20 April 2016

Our ref: 22/17506/112664
Your ref:

Gunnedah Memorial Pool Renewal DA No. 2016/031

Attachment: Design Drawings (22-17506-DA001- C and 22-17506-DA101 – H)

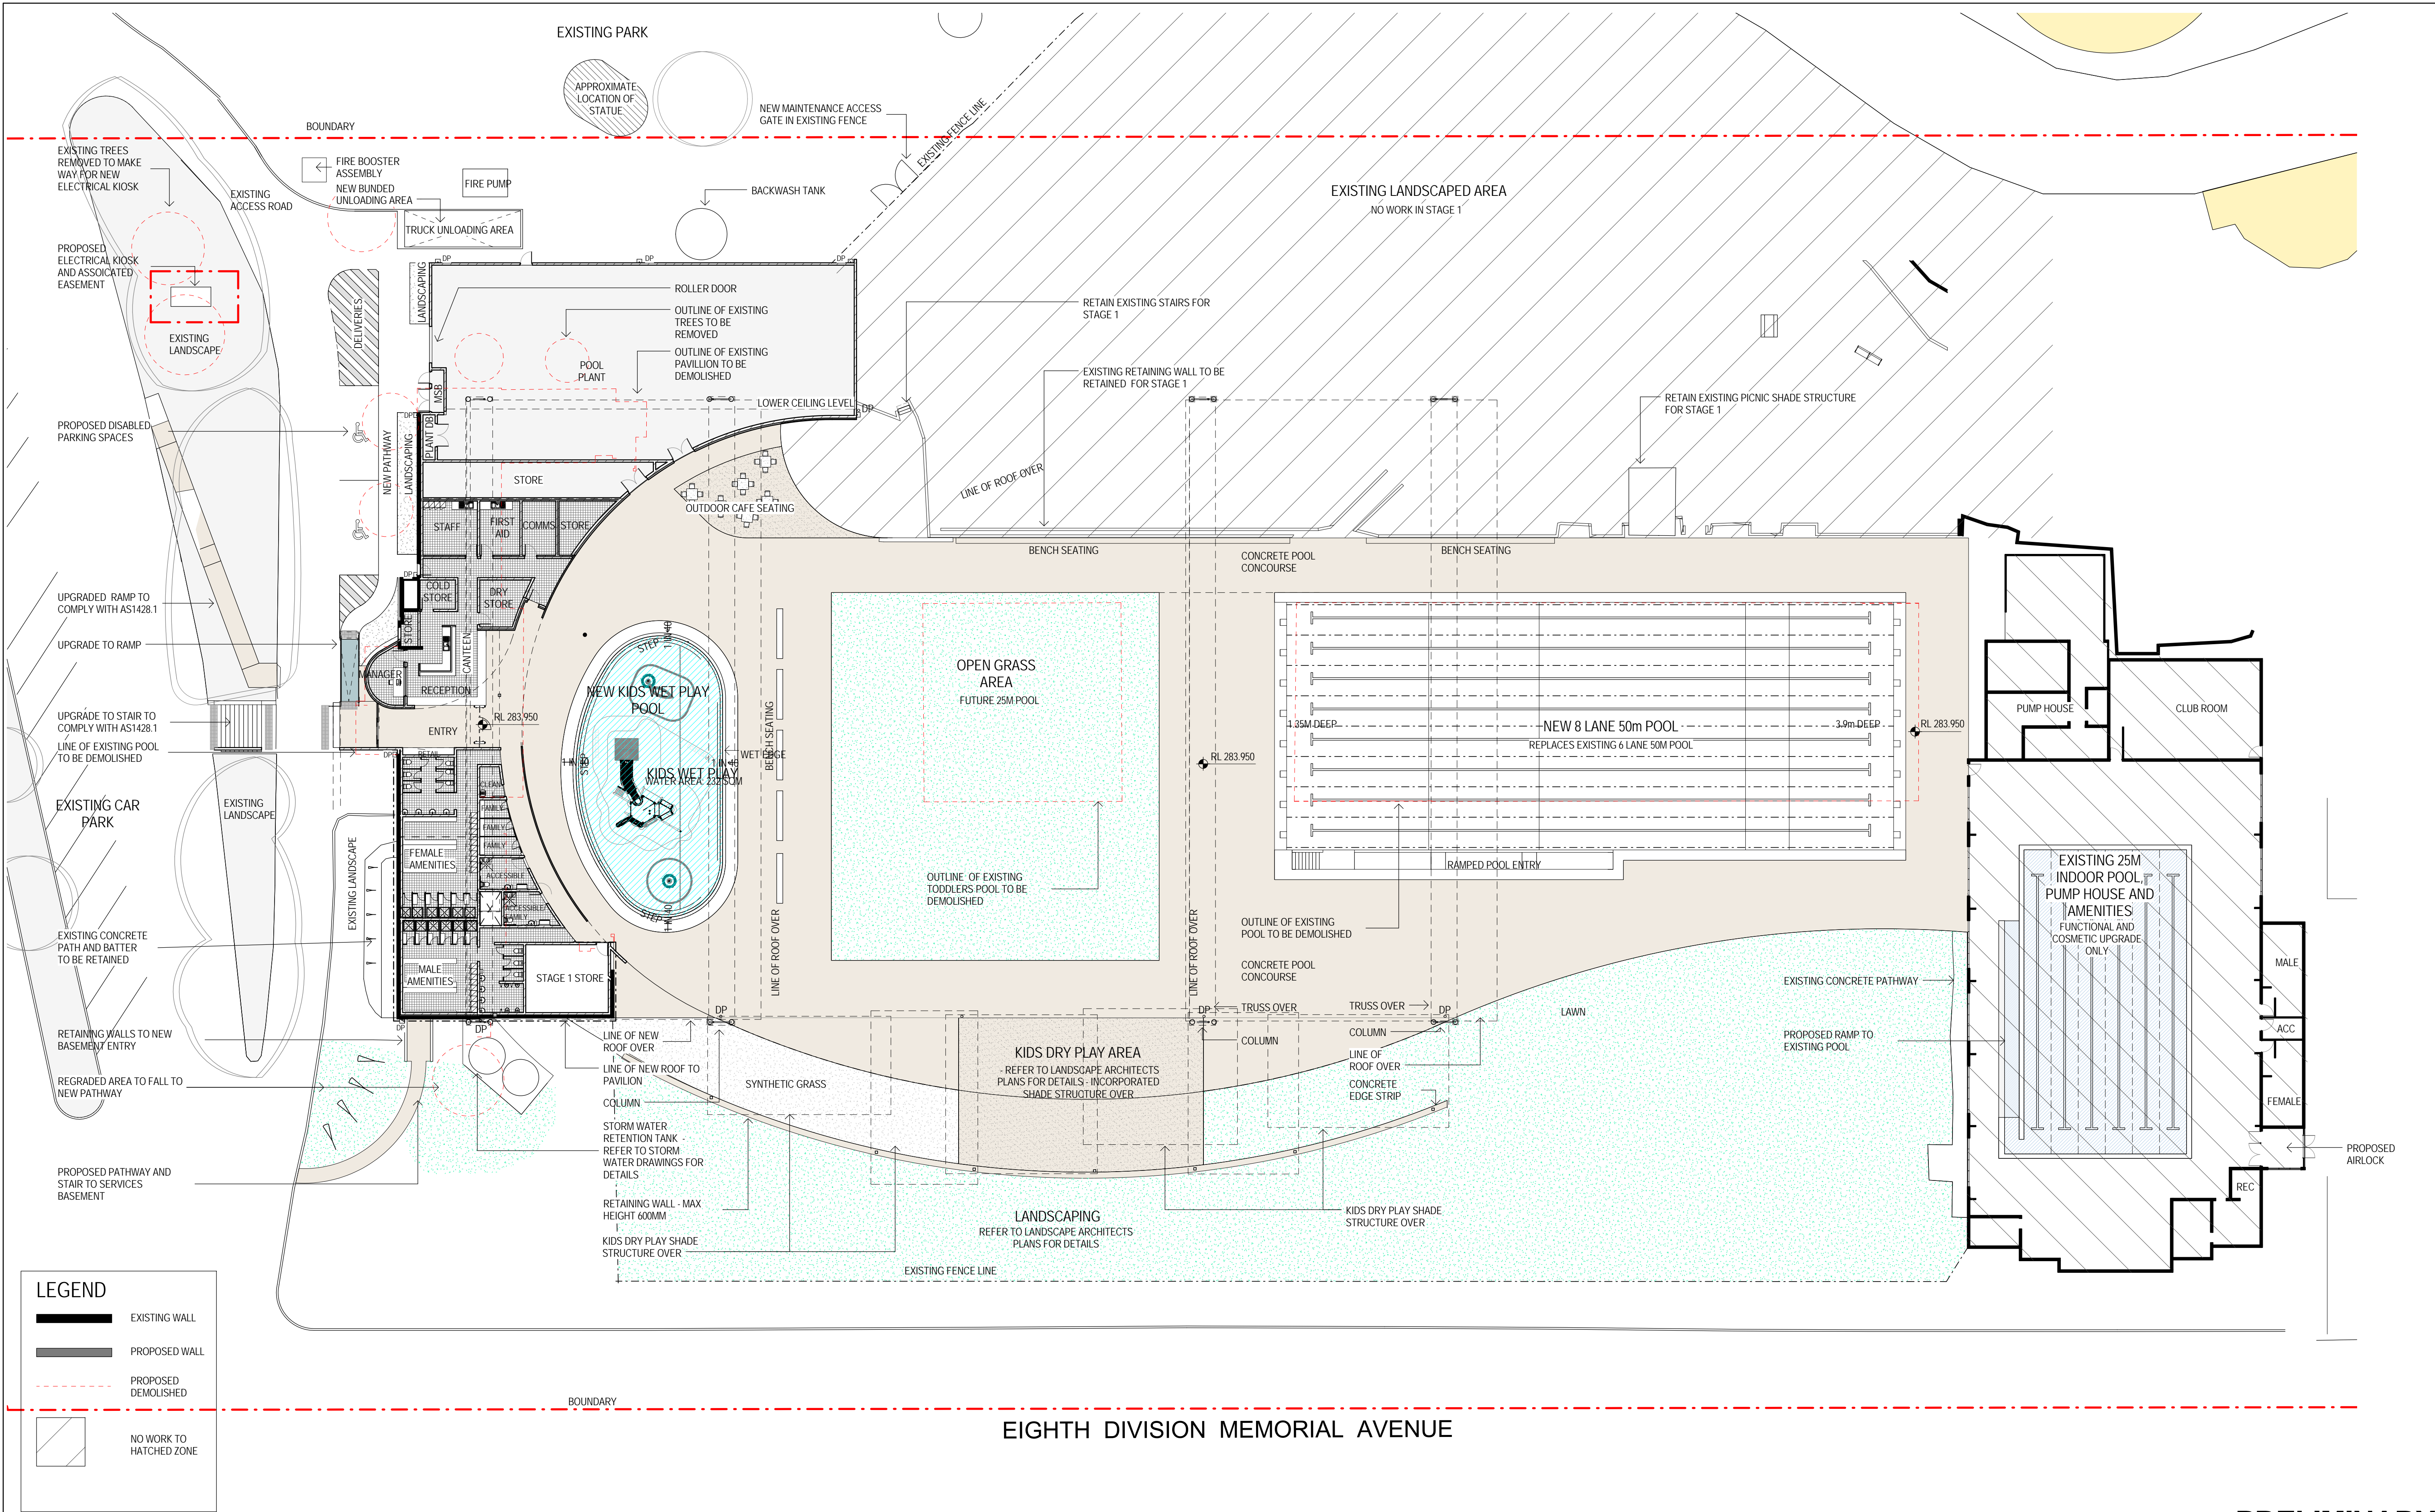
2 Clause 6.2 - Parking

Line marking is only shown for one portion of the existing carpark. GHD has provided an indicative line marking layout compliant with AS2890.1 to determine the number of existing car spaces available at the site. This layout is shown on Drawings 22-17506-DA001- C and 22-17506-DA101 - H attached. The drawings illustrate the following:

- Existing parking spaces:
 - 50 m pool: 88 car spaces + 5 motorcycle parking spaces.
 - 25 m pool: 31 car spaces (shared with Bowling Club).
- Proposed parking spaces: 2 (Disabled spaces).
- Total number of parking spaces (existing and proposed) available - Stage 1: 121 spaces + 5 motorcycle parking spaces.
- For Stage 2, the existing indoor pool will be decommissioned and the carpark excluded from the swimming pool parking.
- Total number of parking spaces (existing and proposed) available - Stage 2: 90 spaces + 5 motorcycle parking spaces.

Since no parking requirements exist for swimming pools in the Gunnedah Development Control Plan 2012, the following calculation has been used to determine peak attendance of 300 people.

- Typically swimming carnivals are for school aged children.
- We would expect approximately 3 people per car with a driving rate of approximately 85% with 15% of the population making their way to the pool by either walking, public transport (bus stop located adjacent to the pool) or by bicycle.
- Patron car parking: 85 spaces.
- Staff parking: 5 spaces.
- **Total Spaces required:** 90 spaces.

The proposed parking arrangement complies with this for both stages of the development. In addition to the on-site parking, ample on-street parking is also available along South Street, Anzac Parade, Eighth Division Memorial Avenue and Acacia Street.
